Response to reviewer #1: AMTD doi:10.5194/amtd-4-4131-2011

We thank this reviewer for comments and suggestions. A revised manuscript has been prepared.

Figure 4 (revised): History of SF₆ precision (%) from all samples analyzed on the GC-ECD systems used for calibrations (color-coded by SF₆ mole fraction (ppt)). Upper plot shows three GC versions. Lower plot shows versions 2 and 3 along with system changes.

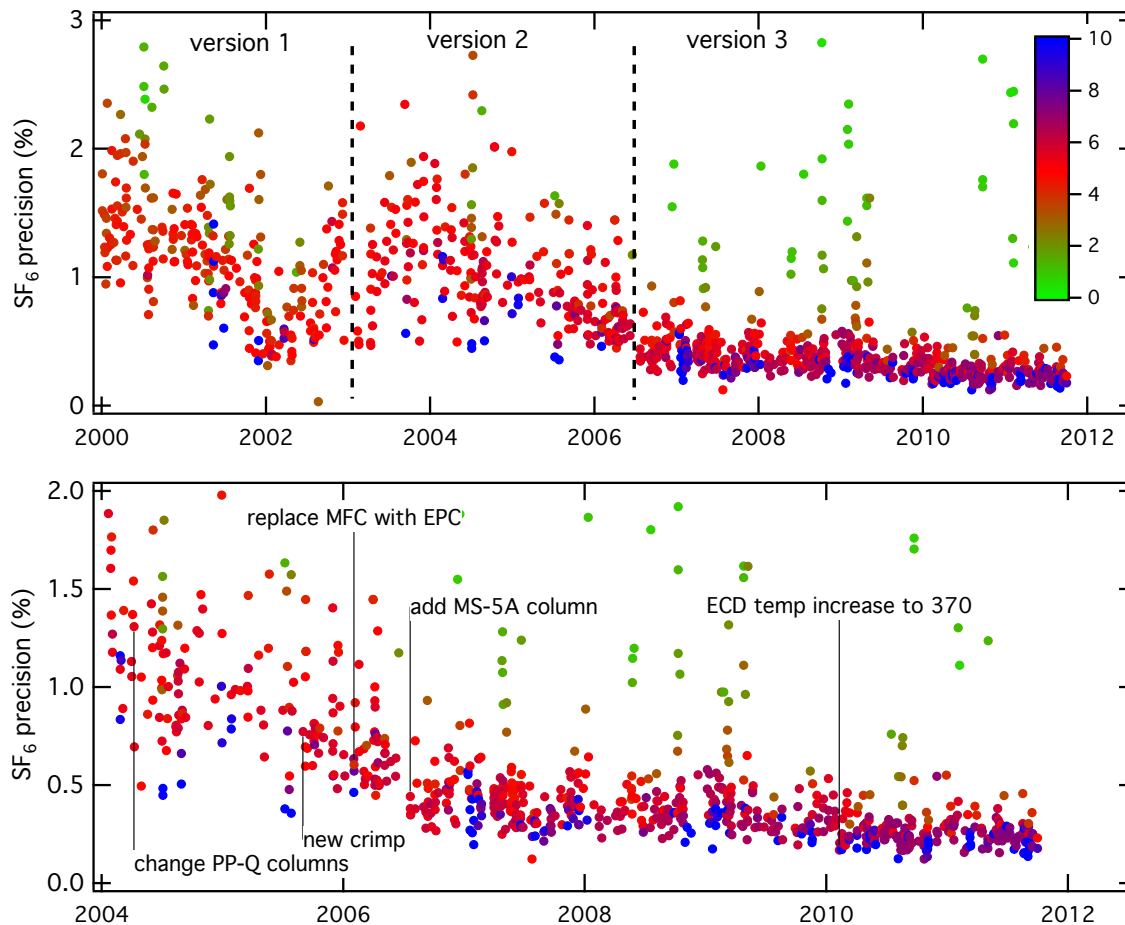
The reviewer notes that the change in SF₆ precision does not seem to be conclusively linked to the addition of the post-column, and could be the result of other factors. We agree that this aspect of the paper was not adequately presented. We maintain that addition of the post-column was a major factor, and have revised text and Figure 4 to support this argument.

- 1) We have modified Figure 4 to include all reference gases analyzed on the calibration instruments (color-coded by mole fraction) and added a second panel to expand the period 2004-2011. Here, we have noted changes to the instrument before and after the addition of the post-column.
- 2) We have revised the first paragraph in section 3.1 as follows:

With the three-column system, the SF₆ precision was improved from 1-2% to better than 0.5%. SF₆ precision determined from analysis of various gas standards is shown in Figure 4. The signal to noise (calculated as SF₆ peak height of a 5.8 ppt sample relative to the standard deviation of the ECD baseline under stable conditions) improved from ~115 to ~160 following the addition of the post-column. The SF₆ peak height increased by 37% while the baseline noise remained unchanged. The mean precision for 5-month periods before and after the addition of the post-column (40 ambient-level samples in each period) was 0.72 (0.24) % and 0.45 (0.13) %, respectively. Prior to the addition of the post-column precision was variable, and seemed to show some improvement in late 2005 resulting from a change in the crimp used to control CO₂ dopant flow. The change from mass flow controllers to electronic pressure controllers (EPC) (early 2006) may have also helped, but the largest improvement corresponds with the addition of the MS-5A post-column in mid-2006. The change in flow controllers did not result in decreased variability of the SF₆ retention time. In fact, a significant reduction in retention time variability occurred following the addition of the post column ($\sigma=0.18$ s with EPC and two columns, $\sigma=0.10$ s with EPC and three columns) rather than with the installation of the EPC. Further, a change in flow controllers (from custom-built MFC to commercial MFC (Pnucleus Technologies, Hollis, N.H.)) on two separate systems using only Porapak-Q columns (installed at South Pole and Summit, Greenland) made little difference to the SF₆ precision.
